**LC 66**

In the Matter of PGE 2016 Integrated  
Resource Plan

Final Comments of  
Renewable Northwest

Figure 1—CO<sub>2</sub> emissions (million short tons by portfolio)<sup>73</sup>

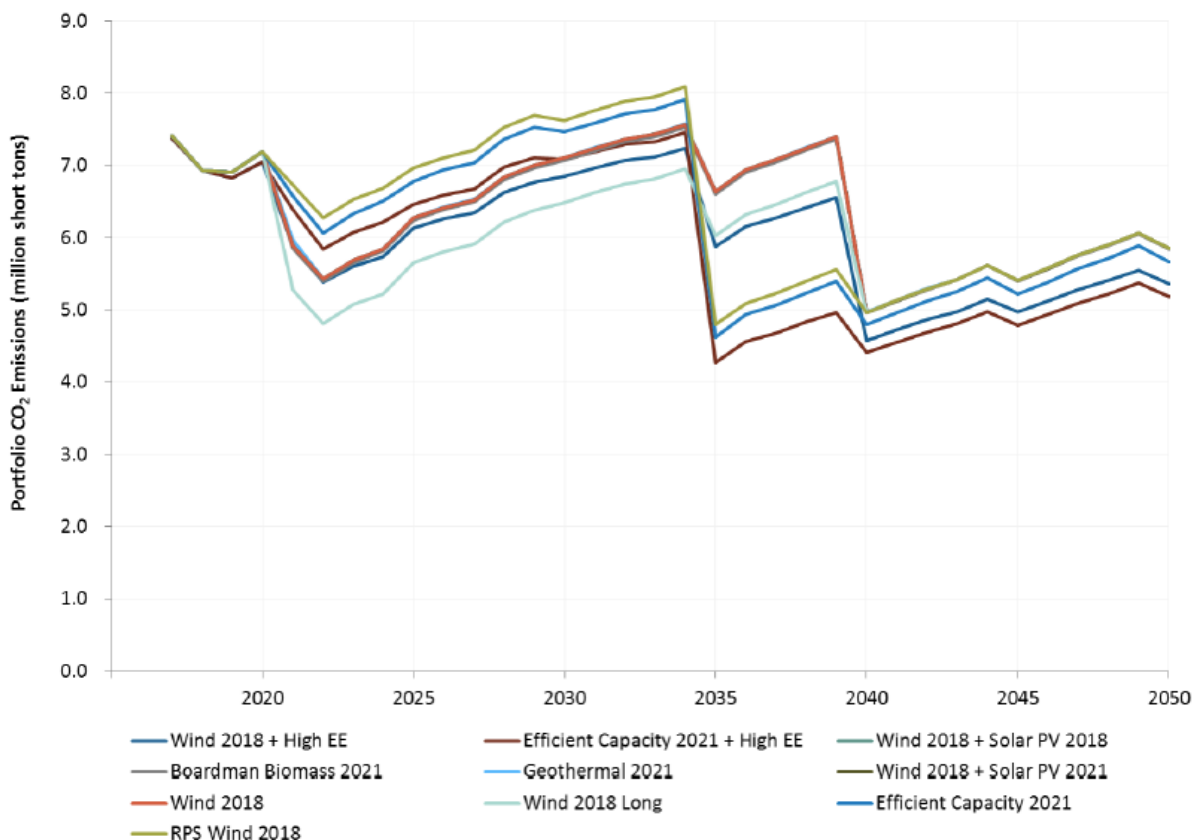
PGE’s regional market assumptions favored its *Efficient Capacity 2021* portfolio. Figure 1 shows the projected carbon dioxide (“CO<sub>2</sub>”) emissions for the actionable portfolios under the reference case assumptions. CO<sub>2</sub> emissions per year from all actionable portfolios settles between a range of just approximately 5 to 6 million tons by 2050. *Wind 2018 Long*, which has 1,599 MW of wind by 2021, is shown to have emissions of approximately 5.8 million tons per year by 2050, while *Efficient Capacity 2021*, which instead has 515 MW of wind and 389 MW of “efficient capacity” modeled as a CCCT<sup>57</sup>, has emissions of approximately 5.6 million tons per year. It is counterintuitive that a portfolio with an additional fossil fuel resource should have lower emissions than a portfolio that instead has more renewables, and is a result of PGE’s assumptions about the regional market.<sup>58</sup> Sierra Club observes that in PGE’s 2016 IRP a CCCT “looks attractive even under high carbon and high gas prices because the Company assumed that such a resource will be more efficient and have a lower emissions rate than the market-at large”.<sup>59</sup>

PGE’s arguments that an efficient CCCT would have a lower emissions rate than the market appear to have relied on the unlikely assumption that carbon prices would not affect western coal capacity. Table 3 shows the cumulative net resource additions from 2017 to 2050 by CO<sub>2</sub> price future. “No CO<sub>2</sub> Tax” represents a “future in which CO<sub>2</sub> emissions are not explicitly priced [...] but CPP [Clean Power Plan] constraints remain in effect (state and provincial CO<sub>2</sub> regimes remain in place).”<sup>61</sup> “High CO<sub>2</sub> Tax” is representative of “\$28 per short ton of CO<sub>2</sub> emissions (nominal) starting in 2022 and escalating at six percent annually through 2027 and eight percent thereafter through 2050”.<sup>62</sup> The High CO<sub>2</sub> Tax case leads to more gas in the WECC, compared to the No CO<sub>2</sub> Tax case, and also has no effect on coal capacity. According to Sierra Club, PGE modeled the “regional market as having a much higher carbon-intensity outside its territory, as a result of its assumption that western coal capacity will not change with different carbon prices.”<sup>63</sup> The Company therefore assumes that a CCCT “will be more efficient and have a lower emissions rate than the market at-large”<sup>64</sup>.

reduce carbon. Because of these flawed assumptions, it is incorrect to conclude that procurement of an additional fossil fuel resource will lead to lower emissions compared to procurement of additional renewable generation.

Figure 2—Capacity Need Impact due to Load and Constraints (Updated April 13, 2017)<sup>78</sup>

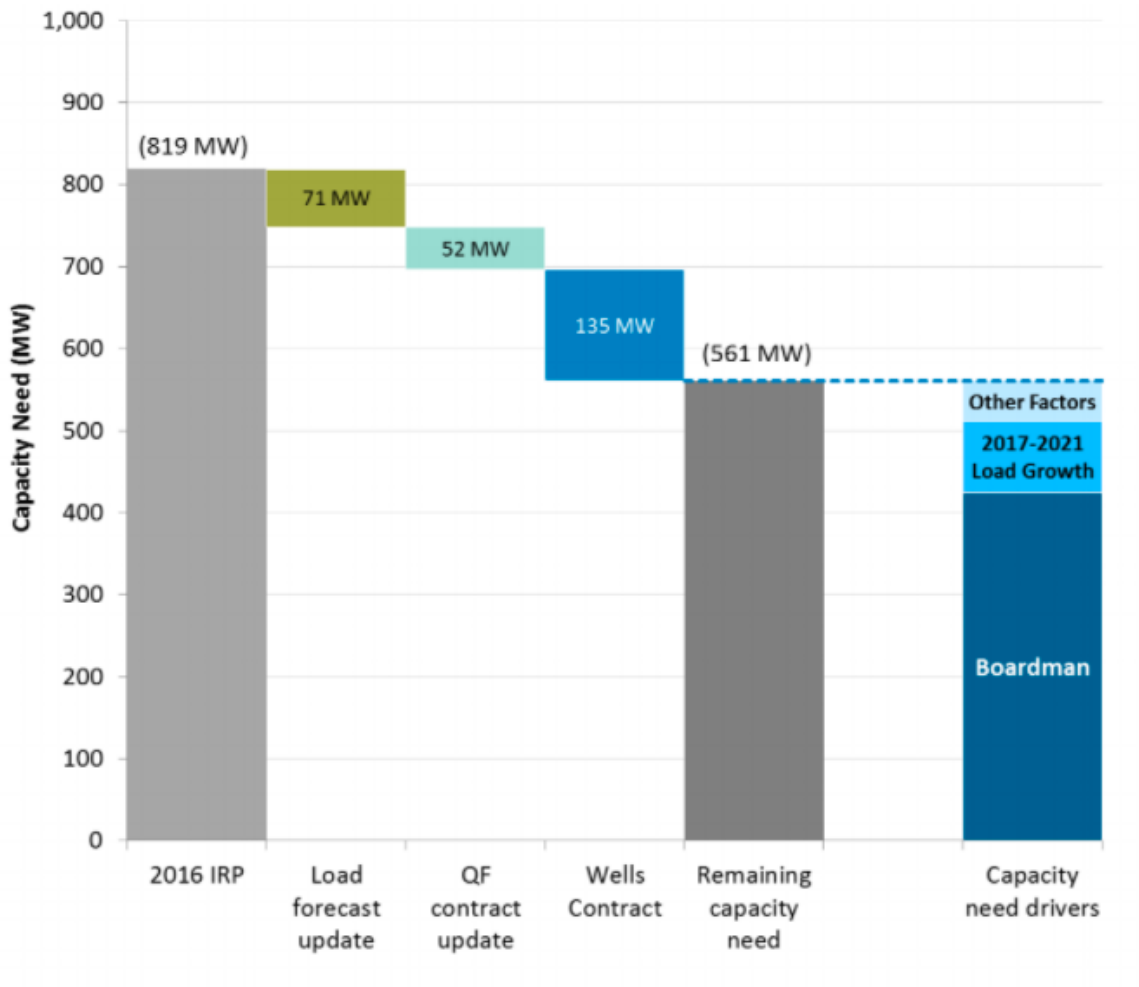
Renewable Northwest supports the pursuit of Competitive Bidding Guideline waivers to enable PGE to meet its remaining capacity needs, as shown in Figure 2. However, PGE's Reply Comments stated that the Company intends to "evaluate potential capacity acquisitions from as many existing resources as possible, including hydro"; this statement implies that thermal resources are also under consideration, likely natural gas.

As discussed in Section IV, 300 MWa of new renewables, if met by wind, could provide firm capacity somewhere between about 93 MW (if entirely in the Pacific Northwest) and about 176 MW (if entirely in Montana). Figure 2 shows that PGE's updated remaining capacity need is 561 MW. To ensure that 300 MWa of NPVRR-minimizing renewable resources could be procured, there would have to be sufficient capacity available after bilateral contracts have been executed. Therefore, Renewable Northwest recommends that PGE undertake procurement in the following order to both minimize NPVRR and minimize carbon dioxide emissions:

- Bilateral hydro contracts between 385 MW and 468 MW;
- Renewable RFP with a minimum procurement of 175 MWa and a maximum procurement of 300 MWa;
- Bilateral hydro contracts to meet remaining capacity need;
- Bilateral thermal contracts with existing resources to meet remaining capacity needs.
